CONTROL SWITCH DEVELOPMENT (C

LA SALLE COUNTY STATION UNIT 2
COMMONWEALTH EDISON CO.
CHICAGO, ILL. 60602

IE-2-4208Av

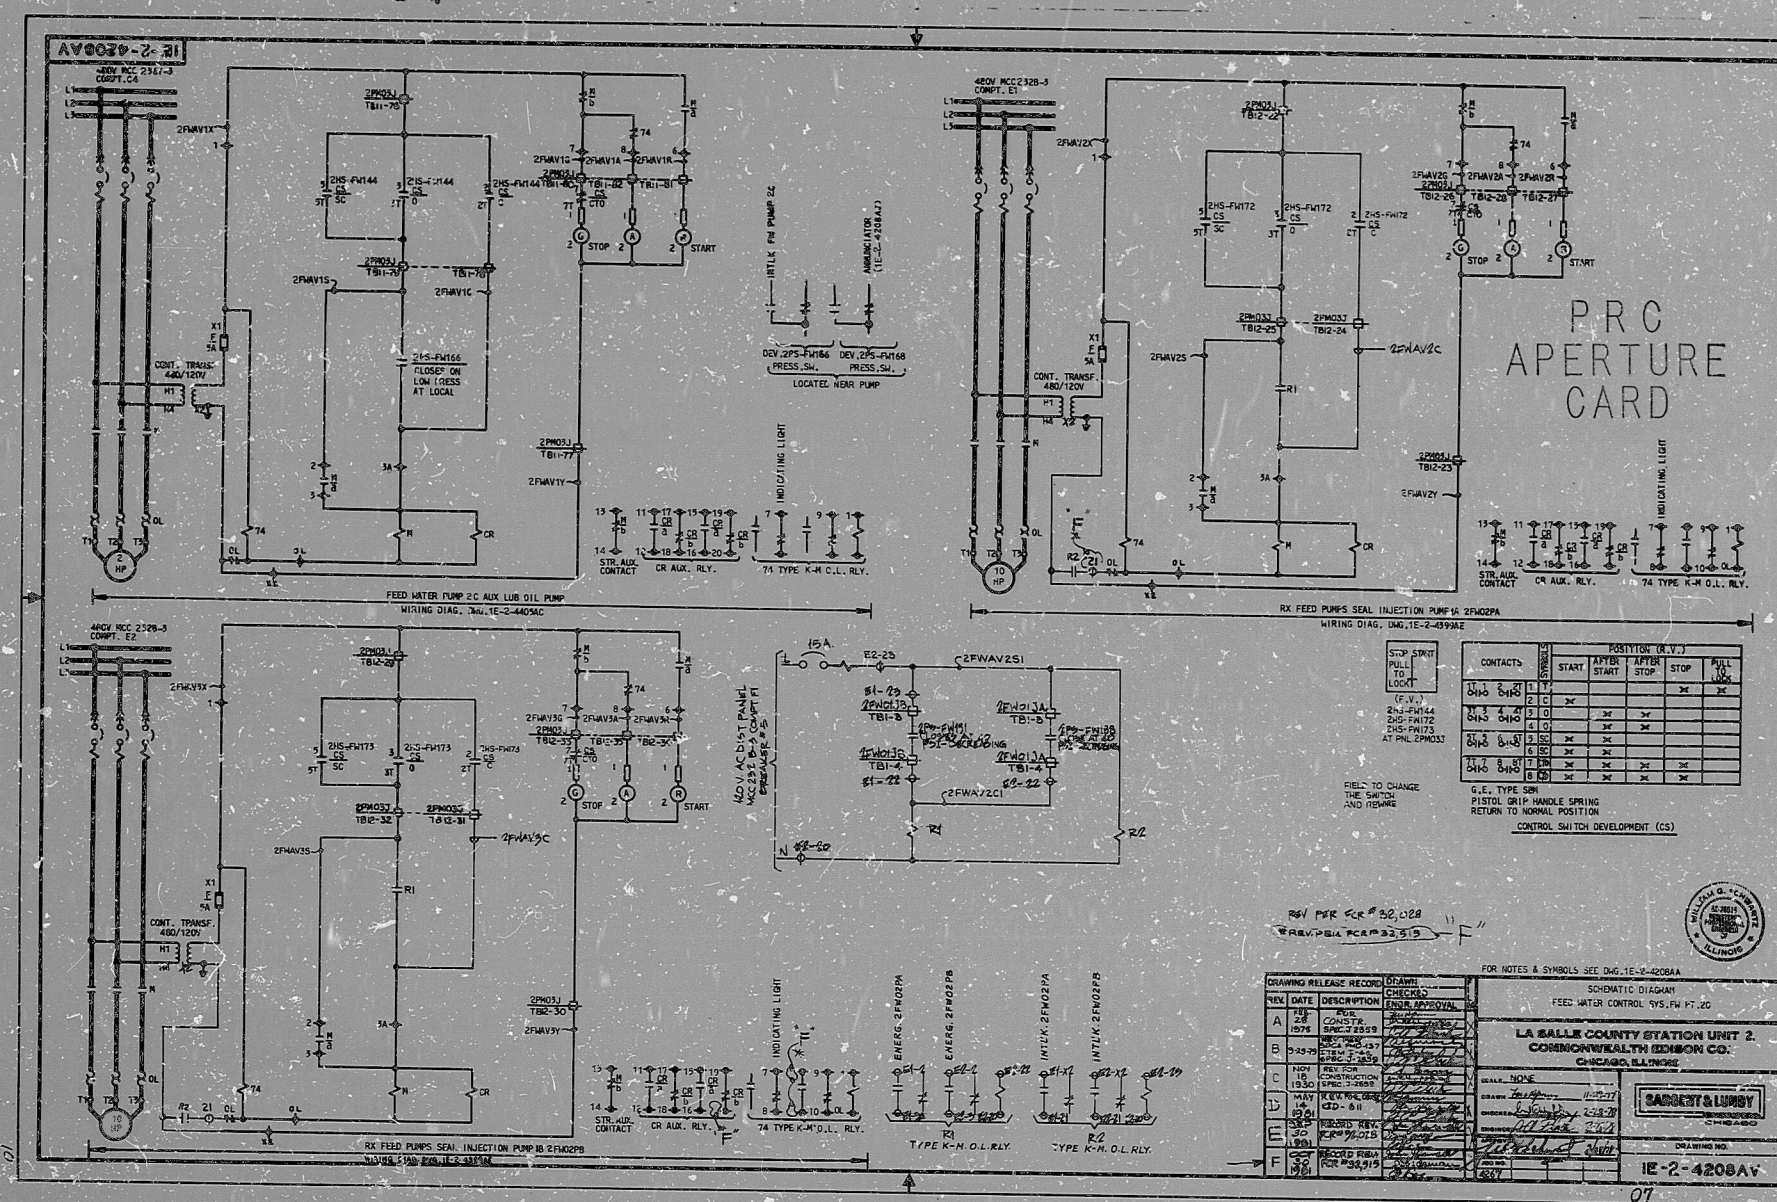
FIELD TO CHANGE
THE SWITCH
AND REWIRE

REV PER ECR # 32,02
REV PER ECR # 32,51
